# Single Pair PoDL PSE Status Register and Variables

George Zimmerman  
CME Consulting/ LTC

# Remein's Comment #333 on D2.0

# PSE State Diagram D2.1 (indicators)

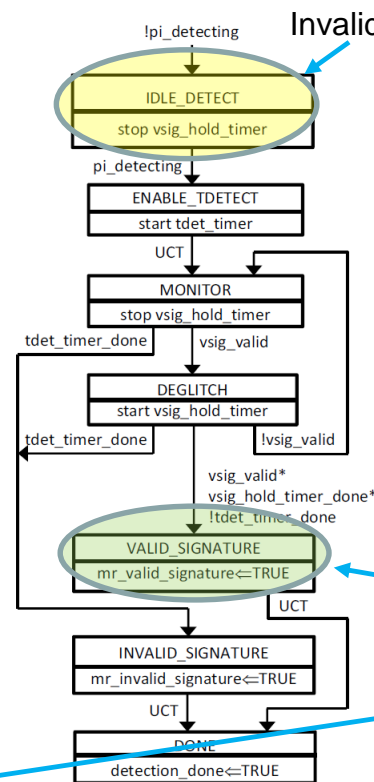
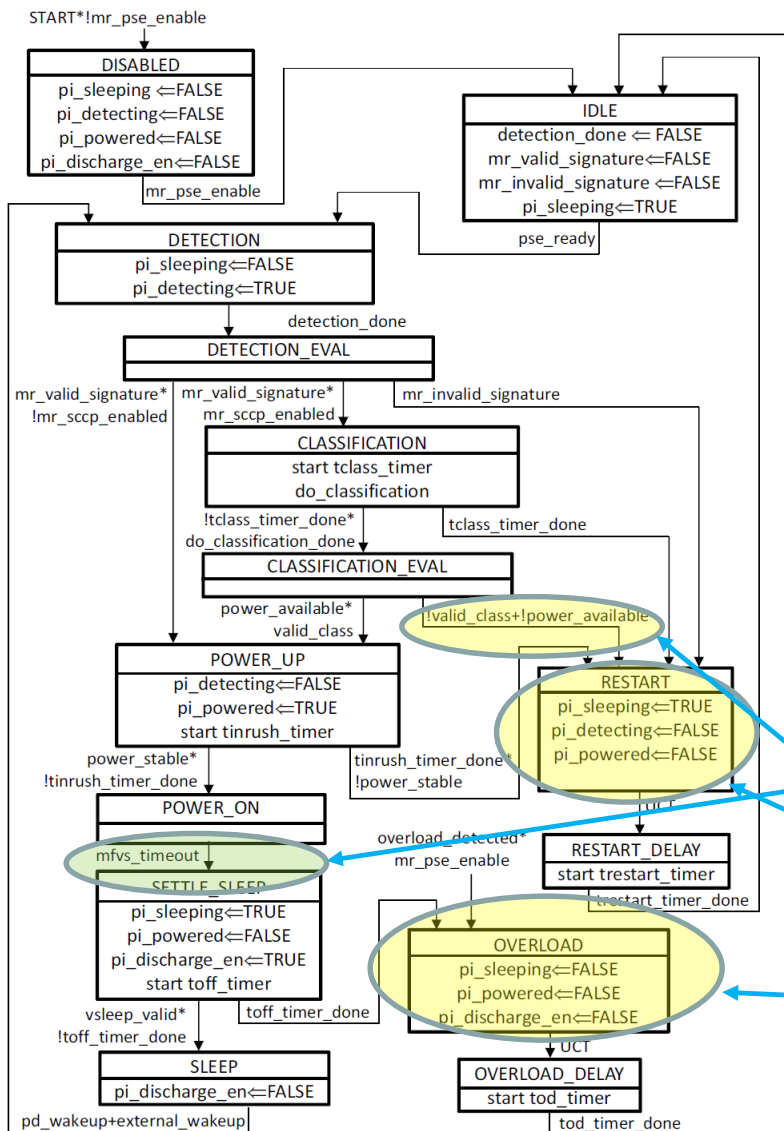
Valid Signature

MFVS Absent

Class Timeout?

Power Removed  
and Overload?

Indicators in Yellow  
have definition  
problems

# State Diagram D2.1 w/ Proposed indicators

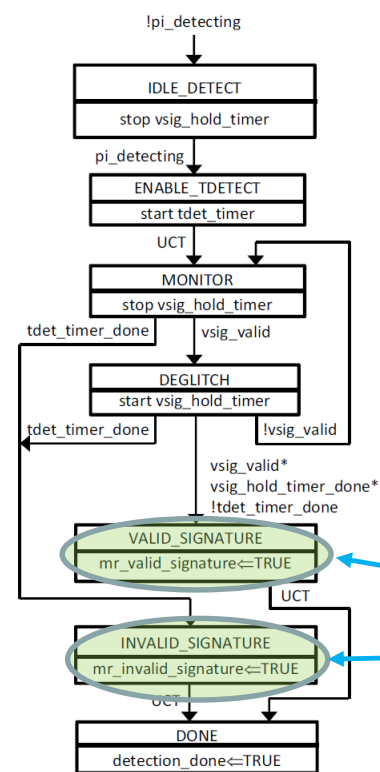
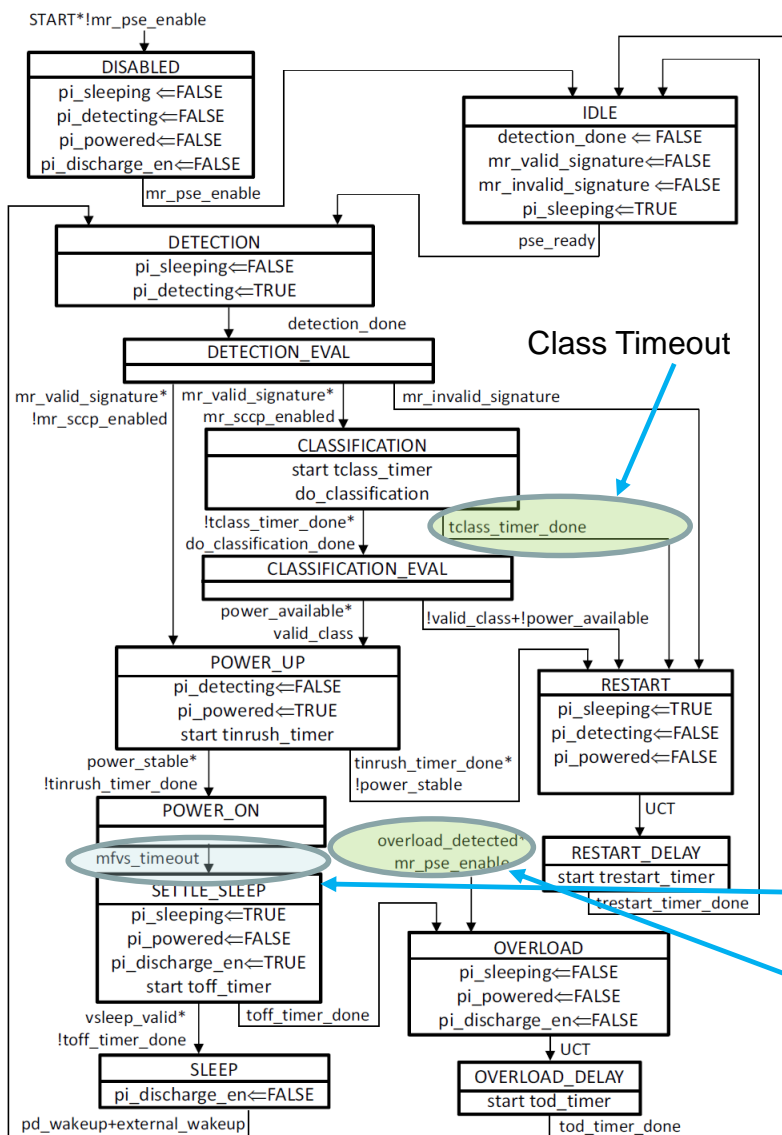
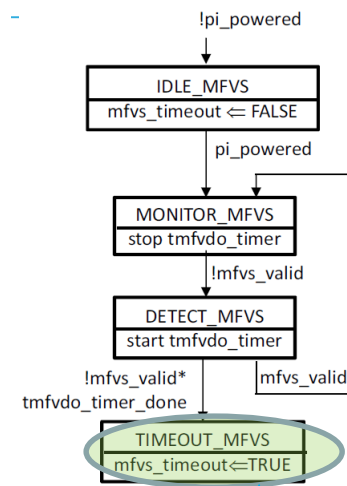
Valid Signature

- Invalid Signature

- MFVS Absent

## Overload

Name	Description	LH?
<del>Power Removed</del> <u>Reserved</u>	Value always 0	
Valid Signature	1 = mr_valid_signature has transitioned to TRUE	LH
Invalid Signature	1 = mr_invalid_signature has transitioned to TRUE	LH
Class Timeout	1 = tclass_timer_done has transitioned to TRUE	LH
Overload	1= overload_detected * mr_pse_enable	LH
MFVS Absent	1=mfvs_timeout has transitioned to TRUE	LH

Figure 104-4: (PSE SD)

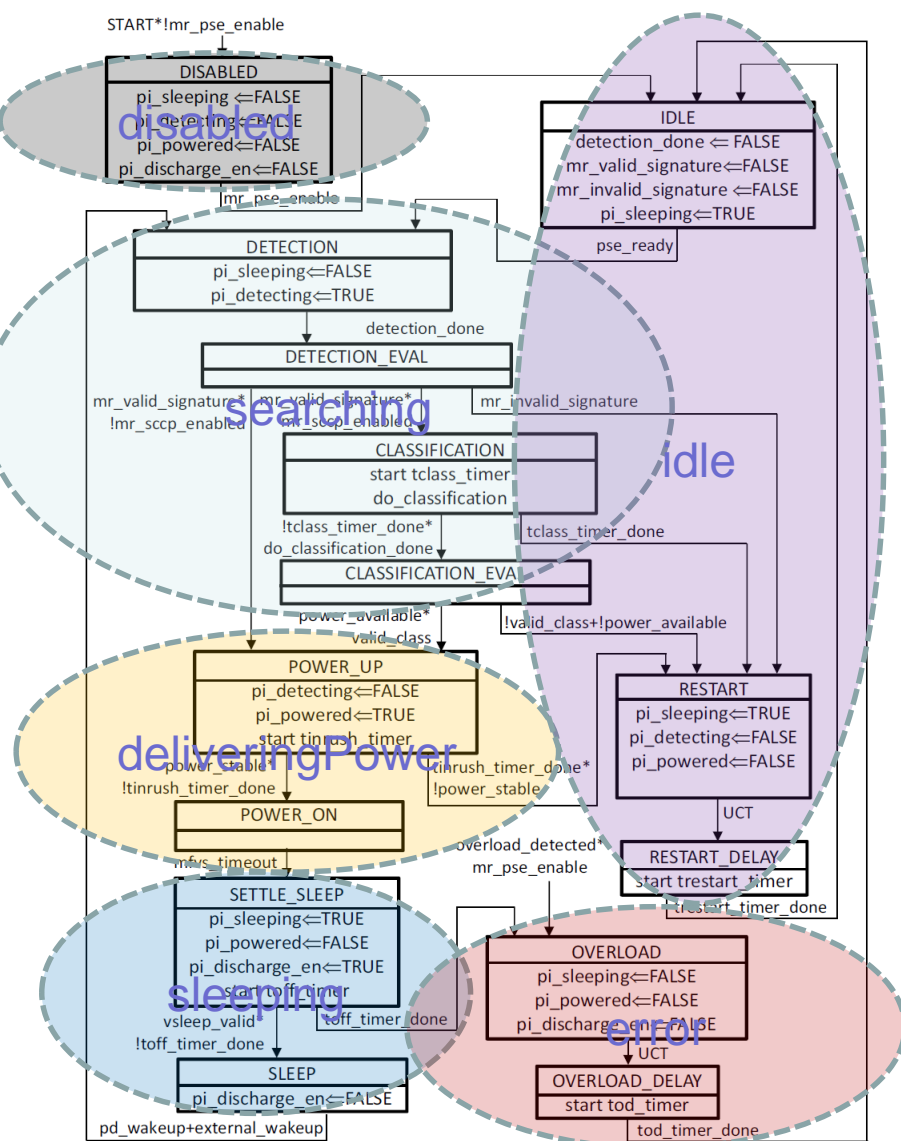
- Redefine pi\_sleeping:

TRUE = PI is in SETTLE\_SLEEP or SLEEP  
FALSE = PI is not in SETTLE\_SLEEP or SLEEP

(note, remove pi\_sleeping from RESTART and IDLE)

- New variable: pi\_prebiased:

TRUE = the circuitry that applies VSleep at the PI is enabled

FALSE = the circuitry that applies VSleep at the PI is disabled

(note, set pi\_prebiased to FALSE in DETECTION state)

- Delete pi\_sleeping <= TRUE in RESTART & IDLE
- Set overload\_held to TRUE in OVERLOAD
- Set overload\_held to FALSE in IDLE
- Set pi\_prebiased to TRUE in RESTART, IDLE
- Set pi\_prebiased to FALSE in DETECTION, DISABLED
- Add “stop tclass\_timer” to CLASSIFICATION\_EVAL

# Proposed Revised SD (A. Gardner)

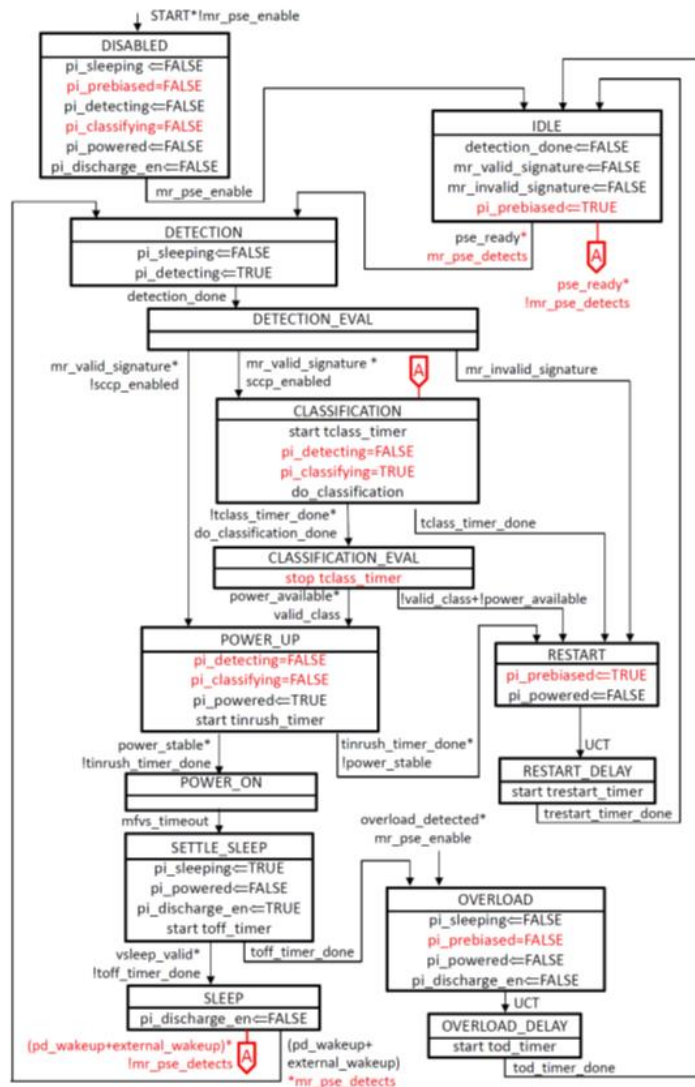
- Revises Detection so that it is optional
  - pi\_detecting turns off after DETECTION\_EVAL
  - pi\_classifying is added
- Includes pi\_prebiased & stop tclass\_timer changes proposed here
  - Still may need 104.3.3 variable changes
  - Still need SD changes for overload\_held, definition,
- These changes mean searching now maps to:

pi\_detecting + pi\_classifying
